# Access Compliance Report

## Public Rights-of-Way

Intersection ID: 10353	Main Street: E_35TH_ST	Cross Street: N_MCDOWELL_ST	Location: W
ADA ID: 959BC8EE9451	Ramp Type: PerpDiag	Initial Pass/Fail: Fail	Overall Compliance: No
		Severity Score: 25

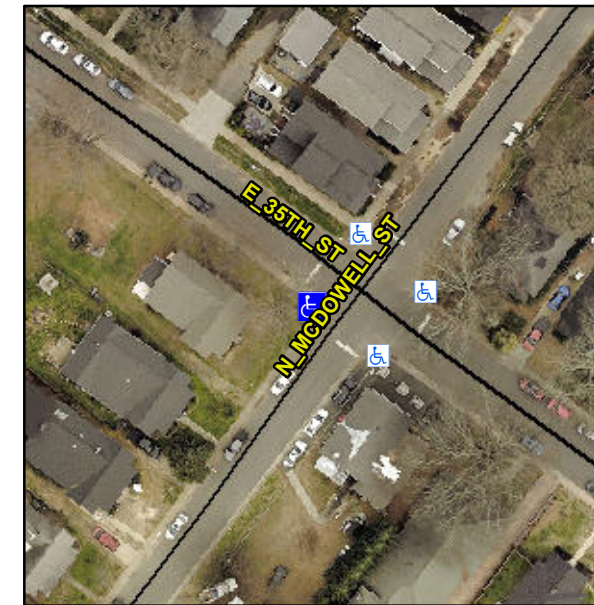
**Not Found, R304.2.2**

Compliance	Description	Data	Compliance	Description	Data
N/A	Ramp Length (in)	56.0	No	Ramp Slope (%)	12.9
Yes	Ramp Width (in)	52.0	Yes	Ramp XSlope (%)	0.4
N/A	Flare Type LT	N/A	N/A	Flare Type RT	N/A
N/A	Flare Slope LT (%)	N/A	N/A	Flare Slope RT (%)	N/A
N/A	Flare Traversable LT?	N/A	N/A	Flare Traversable RT?	N/A
N/A	Landing Length (in)	N/A	N/A	DWS Provided?	N/A
N/A	Landing Width (in)	N/A	N/A	DWS Contrast?	N/A
N/A	Landing Slope (%)	N/A	N/A	DWS Length (in)	N/A
N/A	Landing X Slope (%)	N/A	N/A	DWS Full Width?	N/A
N/A	Landing Curb? (Y/N)	N/A	N/A	DWS Offset (in)	N/A
N/A	Shared Landing?	N/A			
N/A	Gutter Ponding?	N/A	N/A	Gutter Slope (%)	N/A
N/A	Gutter Lip Ht (in)	N/A	N/A	Gutter X Slope (%)	N/A
N/A	Painted X Walk1?	No	N/A	Painted X Walk2?	No
	X Walk 1 Direction	To SE		X Walk 2 Direction	To NE
N/A	X Walk 1 Width (in)	N/A	N/A	X Walk 2 Width (in)	N/A
	X Walk 1 Slope (%)	0.6		X Walk 2 Slope (%)	4.4
	X Walk 1 X Slope (%)	1.9		X Walk 2 X Slope (%)	1.3

**Remove & Replace Curb Ramp With Two New Directional Ramps or Equivalent.**
